Technical Service BULLETIN

HEAT SHIELD RATTLE

'02 Camry

REVISED
NV002-02
NVH

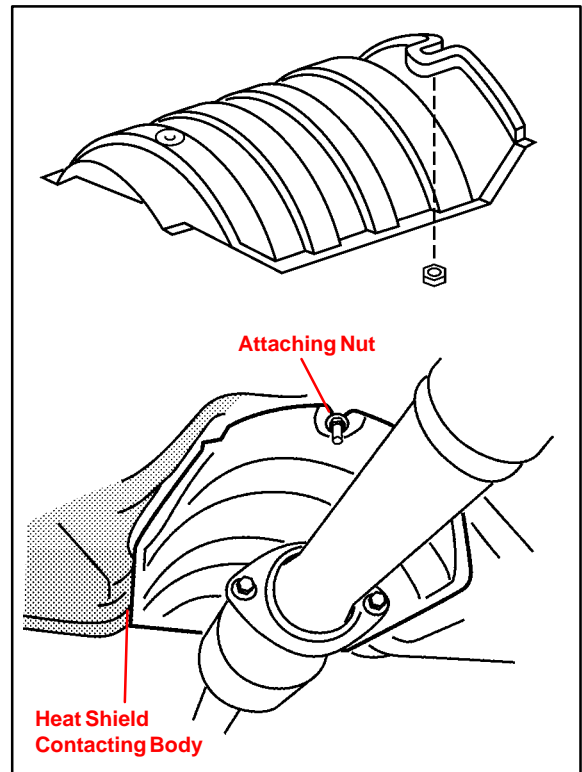
Introduction Under certain conditions, the heat shield for the catalytic converter on some 2002 model year Camry vehicles may be the source of a rattling sound. This rattle noise is most noticeable when driving at vehicle speeds above 50 mph, at which time, the air passing under the vehicle may cause the heat shield to vibrate and contact the body. As a result of this, the heat shield may generate a metallic rattle that sounds like it emanates from the dash or center console area.

1. While wearing work gloves, loosen the two nuts that attach the heat shield to the vehicle body.

2. Reposition the heat shield to center it, ensuring a minimum of 10 to 15 mm of clearance between both sides of the heat shield and the vehicle body.
3. If the heat shield is too wide to obtain the necessary clearances using the procedure in step 2, reposition both the left and right outer edges of the heat shield inward until the minimum clearance has been established.
4. Re-tighten the nuts securing the heat shield to the vehicle body.
5. Test drive the vehicle at speeds above 50 mph to verify the effectiveness of the repair.
